# Access Compliance Report

## Public Rights-of-Way

### (Curb Ramps)

Intersection ID: 10570	Main Street: HERRIN_AV	Cross Street: HOLT_ST	Location: NE
ADA ID: 34A169F8B8E1	Ramp Type: BlendTrans2	Initial Pass/Fail: Fail	Overall Compliance: No
Severity Score: 33.75			
Codes/Mitigation Info/Possible Solution		Field Measurements/Component Compliance

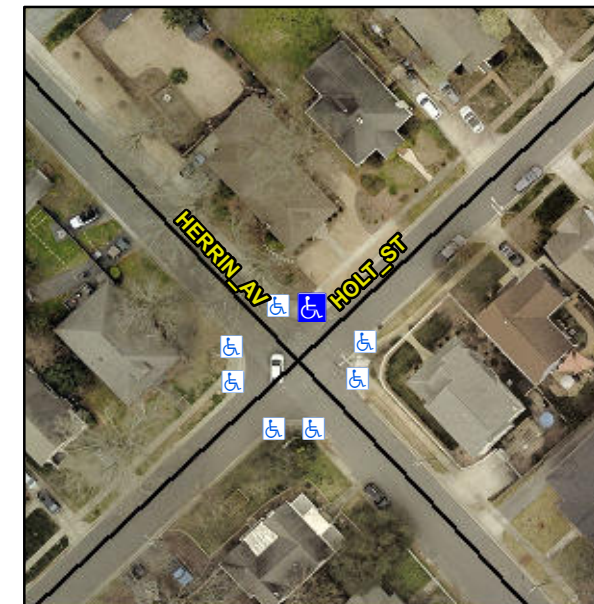
**Not Found, R304.5.1, R304.5.3**

Compliance	Description	Data	Compliance	Description	Data
N/A	Ramp Length (in)	93.0	Yes	BlendTrans Slope (%)	4.7
No	Ramp Width (in)	46.5	No	BlendTrans XSlope (%)	7.7
N/A	Flare Type LT	N/A	N/A	Flare Type RT	N/A
N/A	Flare Slope LT (%)	N/A	N/A	Flare Slope RT (%)	N/A
N/A	Flare Traversable LT?	N/A	N/A	Flare Traversable RT?	N/A
N/A	Landing Length (in)	N/A	N/A	DWS Provided?	N/A
N/A	Landing Width (in)	N/A	N/A	DWS Contrast?	N/A
N/A	Landing Slope (%)	N/A	N/A	DWS Length (in)	N/A
N/A	Landing X Slope (%)	N/A	N/A	DWS Full Width?	N/A
N/A	Landing Curb? (Y/N)	N/A	N/A	DWS Offset (in)	N/A
N/A	Shared Landing?	N/A			
N/A	Gutter Ponding?	N/A	N/A	Gutter Slope (%)	N/A
N/A	Gutter Lip Ht (in)	N/A	N/A	Gutter X Slope (%)	N/A
N/A	Painted X Walk1?	No	N/A	Painted X Walk2?	N/A
	X Walk 1 Direction	To SE		X Walk 2 Direction	N/A
	X Walk 1 Width (in)	N/A		X Walk 2 Width (in)	N/A
	X Walk 1 Slope (%)	2.3		X Walk 2 Slope (%)	N/A
	X Walk 1 X Slope (%)	1.4		X Walk 2 X Slope (%)	N/A

N/A	Ramp inside XWalk1?	N/A	N/A	Ramp inside XWalk2?	N/A
	Road Slope (%)	1.4		Clear Space?	N/A
	Road X Slope (%)	2.3	N/A	Clear Space to XWalk (in)	N/A
N/A	Any Obstructions?	N/A	N/A	Storm Grate/Utility Hazard?	N/A
	Obstruction Type			Storm Grate/Utility Type	
		N/A			N/A
			Yes	Surface Condition? (G/P)	Good
			No	Curb Slope (%)	27.9

**Remove & Replace Curb Ramp With Two New Directional Ramps or Equivalent.**
